WIRING OF VCH1000/VCHE250 CABINET HEATER 5.5kW MOTOR.

DOC REF GB/TB/023/0207

fig.1 - DELTA terminal link configuration

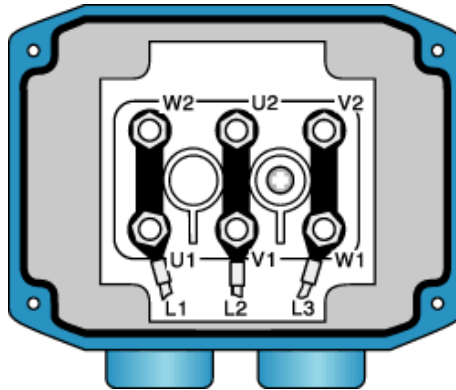
The 5.5kW motors used during the production of the Warm Air Cabinet **VCH1000/VCHE250** have changed. The new motor has a higher dual voltage of **400V/690V** and will only function correctly when wired in a **DELTA configuration**.

If the information displayed is **400V/690V**, then the terminal links **MUST BE WIRIED IN A DELTA CONFIGURATION** (see fig.1).

Although the running current remains at approximately 11.5 amps (free-standing heater), if this motor is wired in STAR by error, the actual motor speed would increase to between 1350 and 1400rpm.

As the motor is designed to be operated in delta, then operating continuously in star can cause damage to the motor. The voltage across, windings and magnetising current

torque capacity of the motors are reduced.

Operating at high loads as in cabinet heaters, will cause the slip of the motor to be increased dramatically and it may stall.

This will result in a dramatic increase in the power dissipated in the rotor. If the motor begins to stall, the starter will also suffer excess heating causing a motor failure.

When rewiring a replacement motor on this size cabinet heater, ensure the terminal links are correct to the sketch in fig.1 and adjust if necessary.

If the cabinet heater is identified as one included in the serial numbers shown below, en-

sure the terminal links are correct to the sketch in fig.1 and adjust if necessary.

If the cabinet heater displays any of the symptoms above check the terminal links are correct to the sketch in fig.1 and adjust if necessary.
